# NOTICE OF DECISION

### SUBDIVISION / URBAN GROWTH PRELIMINARY DECLARATION CASE NO. SUB-UGA17-08

**REQUEST:** A consolidated application for a 20-lot phased subdivision ("Illahe River Estates") on the north side of River Road S, containing the following requests:

<b>IN THE MATTER OF THE APPROVAL OF ) CONSOLIDATED URBAN GROWTH ) PRELIMINARY DECLARATION AND ) TENTATIVE PHASED SUBDIVISION PLAN ) CASE NO. SUB-UGA17-08; ) 3906 CORREDALE DRIVE S )</b>	<b>FINDINGS AND ORDER     SEPTEMBER 29, 2017</b>
---	--

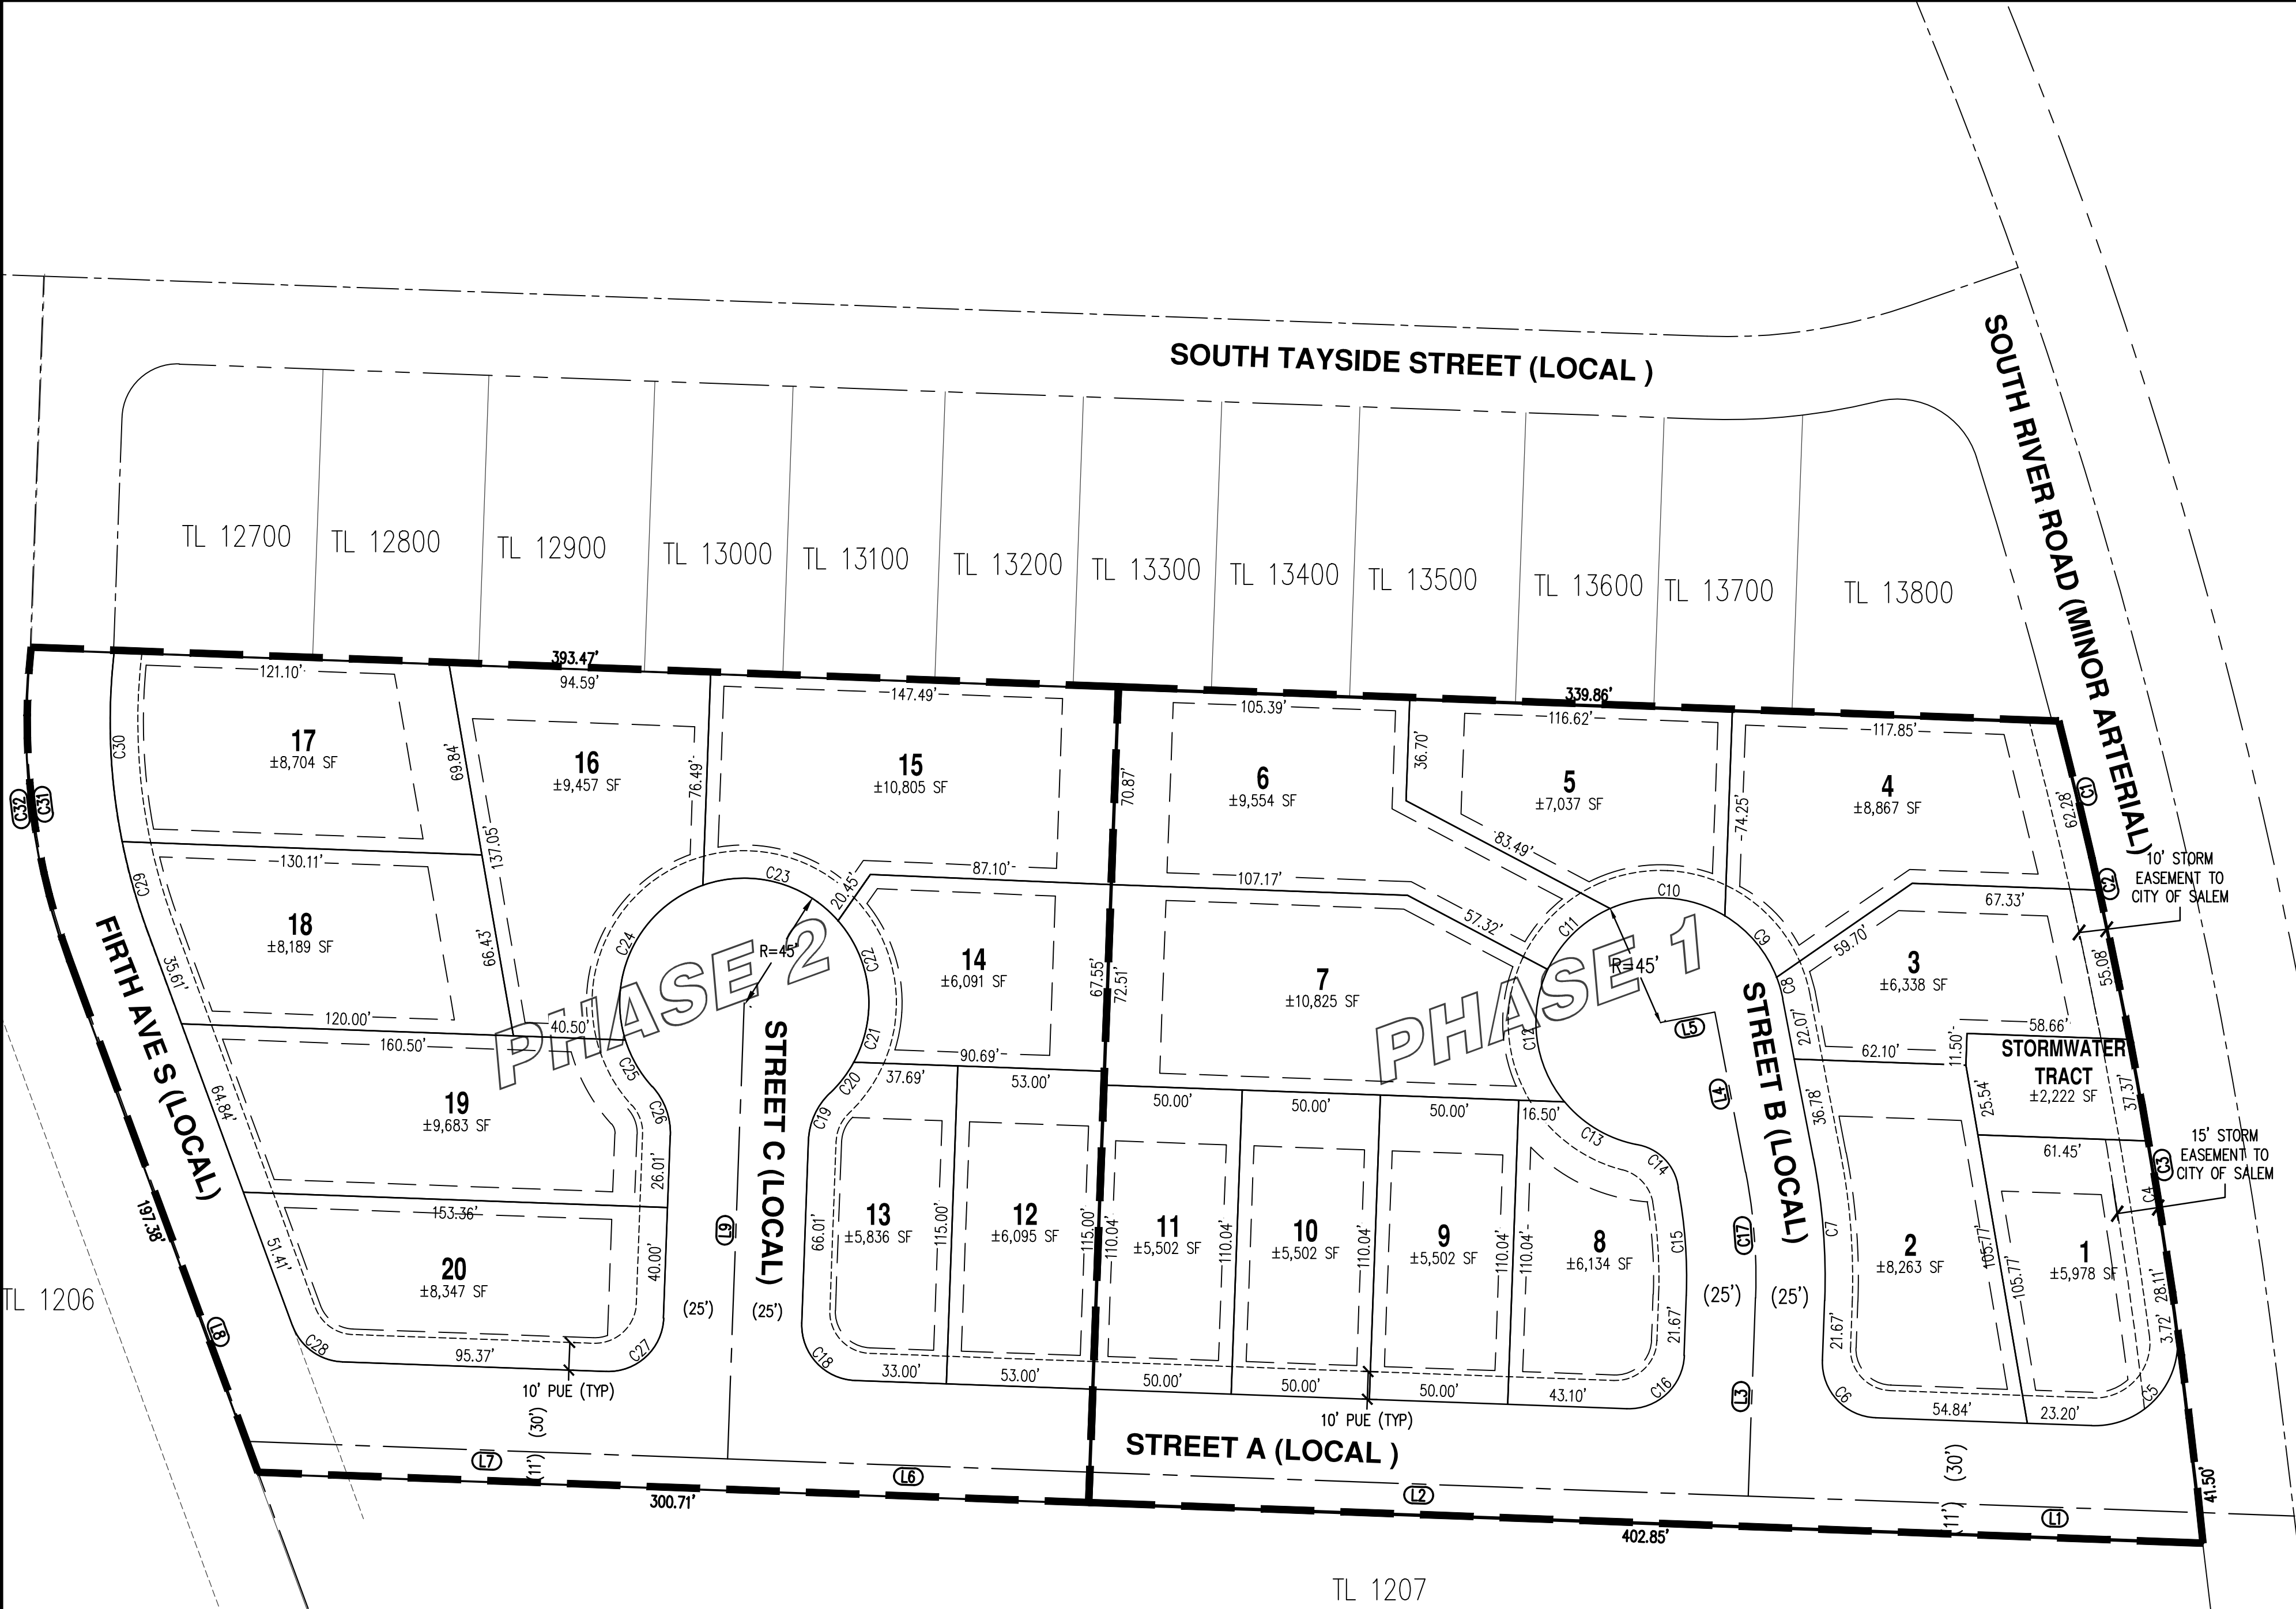
The tentative plan proposes to divide 4.96 acres into 20 lots for residential development (Attachment B), with development taking place in two phases. Phase 1 would include 11 lots ranging in size from 5,502 square feet to 10,825 square feet, located on the southern portion of the subject property. Access to Phase 1 would be provided from River Road S, via a three-quarter street extending northward from the southwestern corner of the subject property (Street 'A') and an eastward cul-de-sac (Street 'B'). The proposal also includes an approximately 2,222 square foot area along the River Road frontage for construction of a stormwater pond, which would be dedicated to the City.

**Condition 8:** On the final plat of Phase 1, convey land for dedication of right-of-way for Street 'A' and Firth Avenue S within both Phase 1 and Phase 2 of the phased tentative subdivision plan.

SCHEMATIC UTILITY PLAN

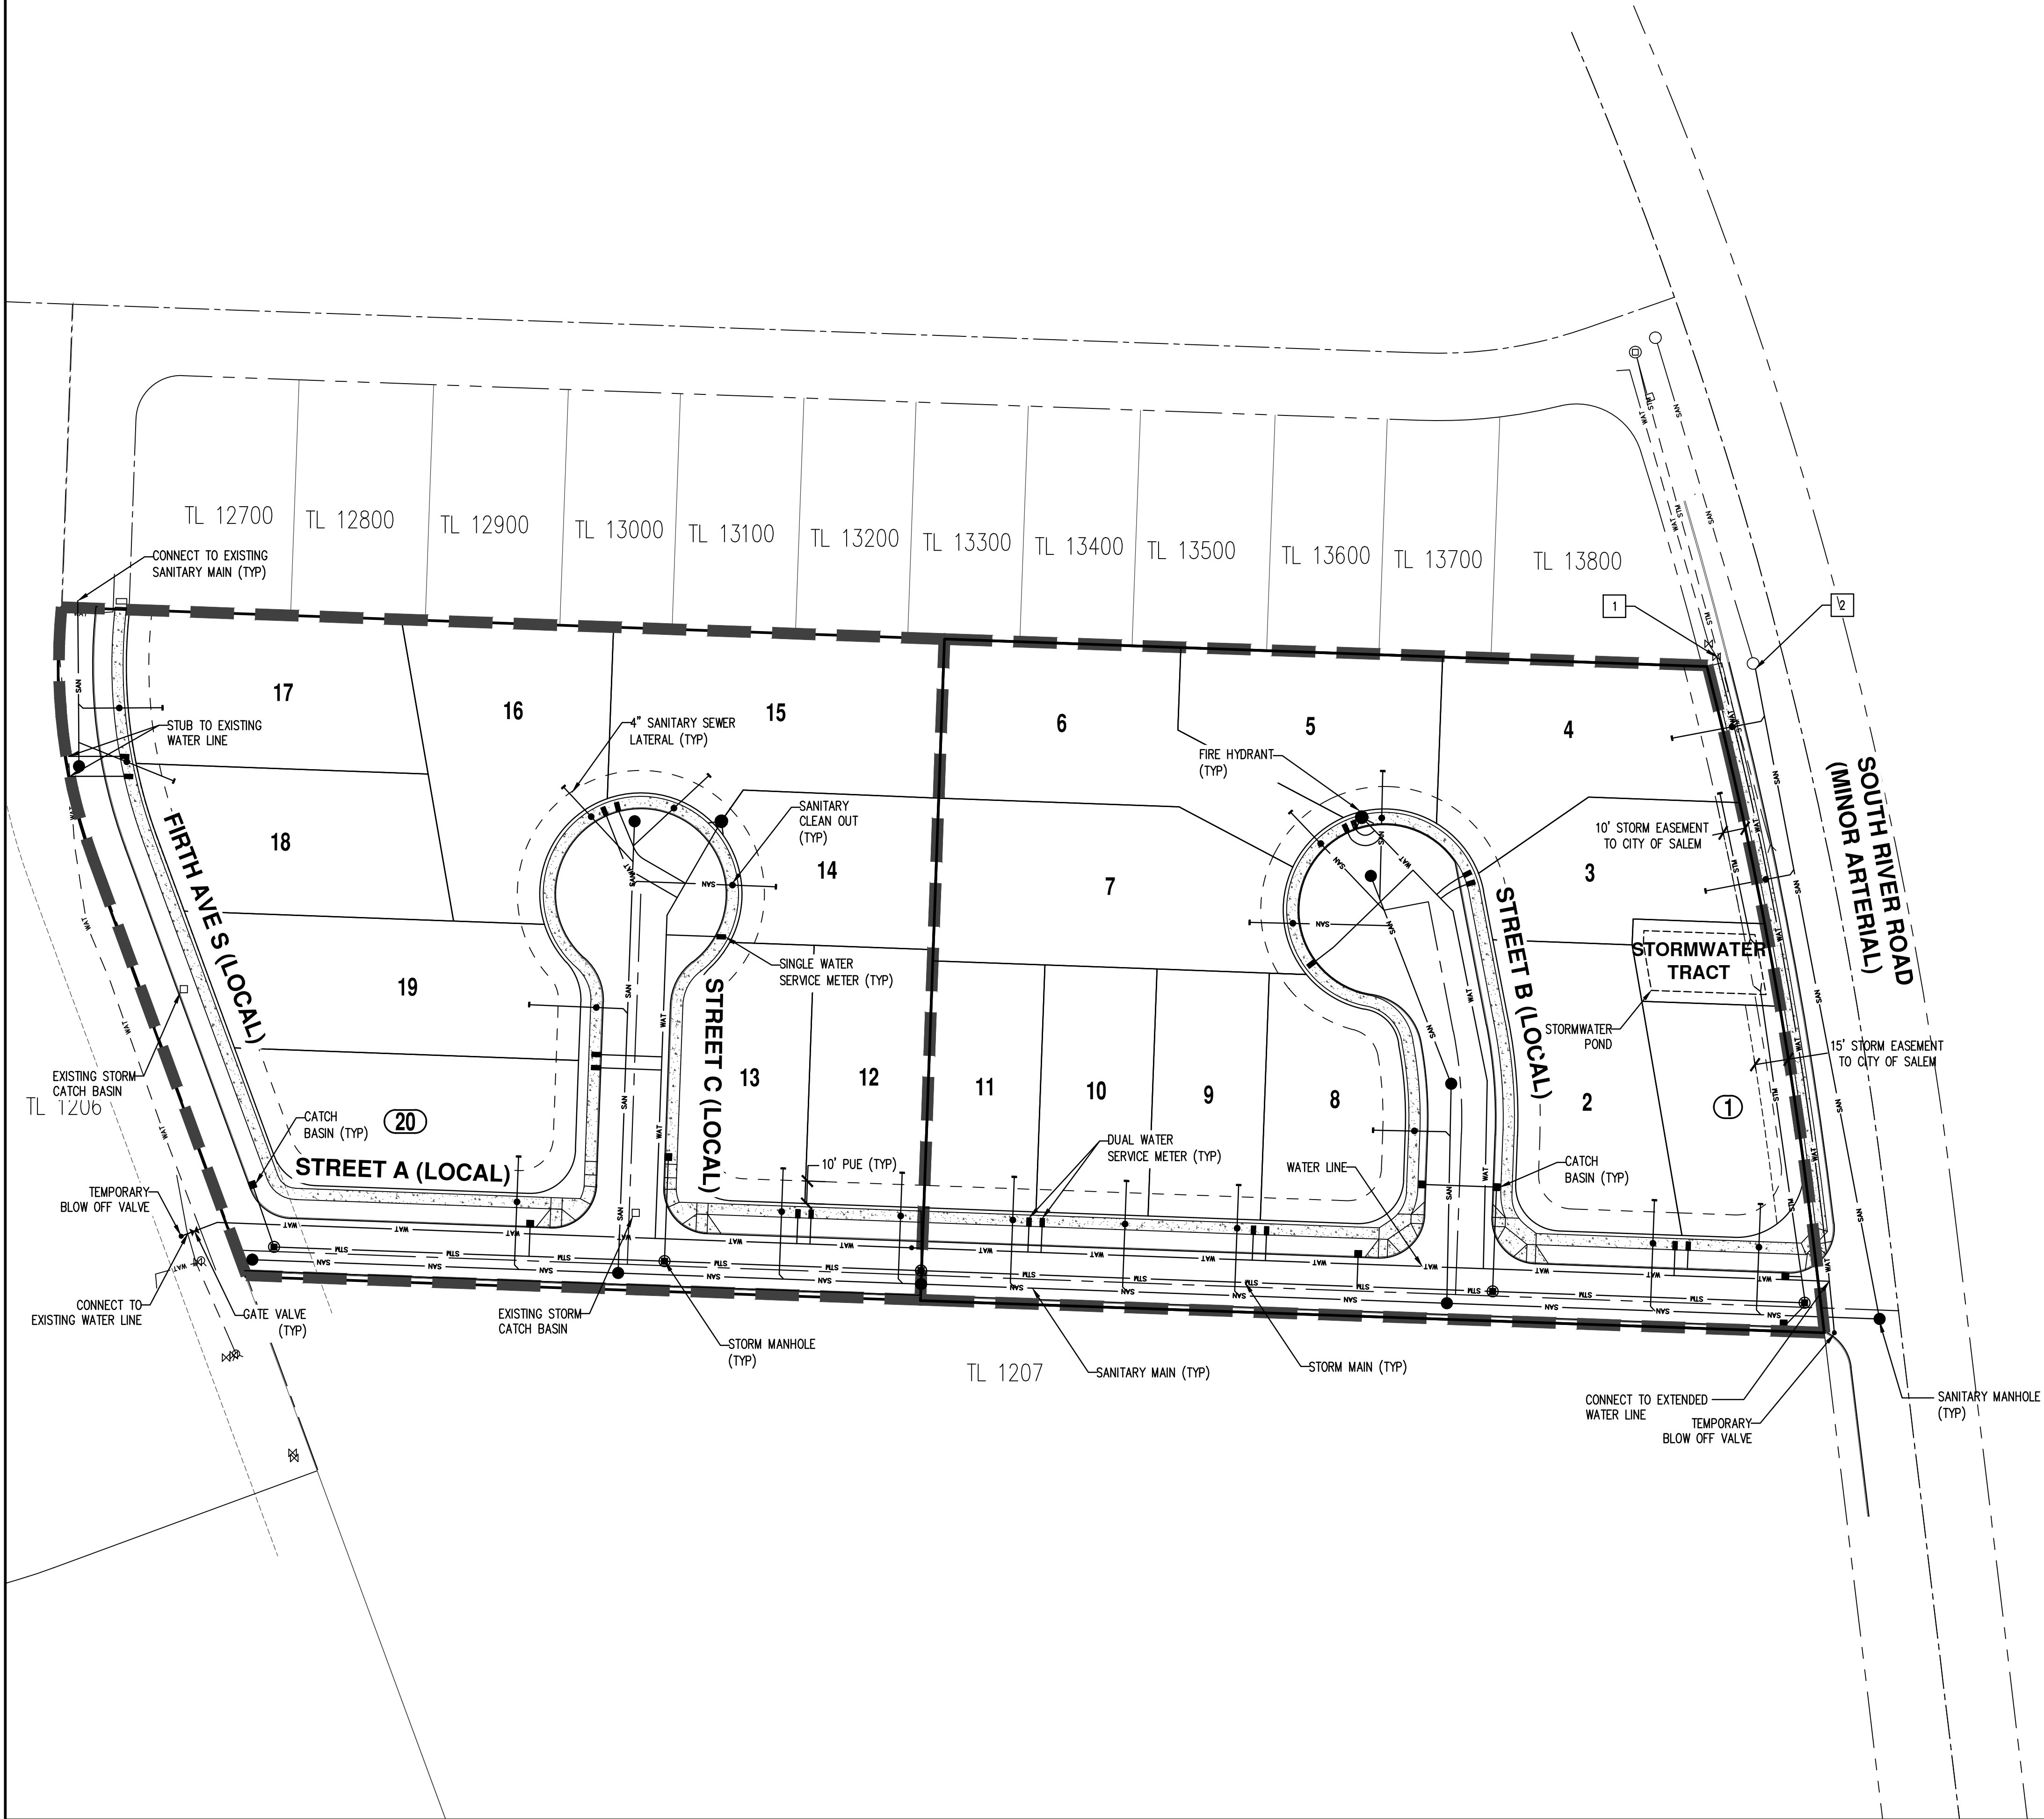
and Public Works Design Standards. The Schematic Utility Plan submitted by the applicant (Attachment C) shows that each individual lot can be served by City utilities designed and constructed according to the applicable provisions of the SRC and PWDS.

**Condition 5:** Construct public water, sewer, and storm systems within the proposed development as depicted on the schematic utility plan and in compliance with Public Works Design Standards.
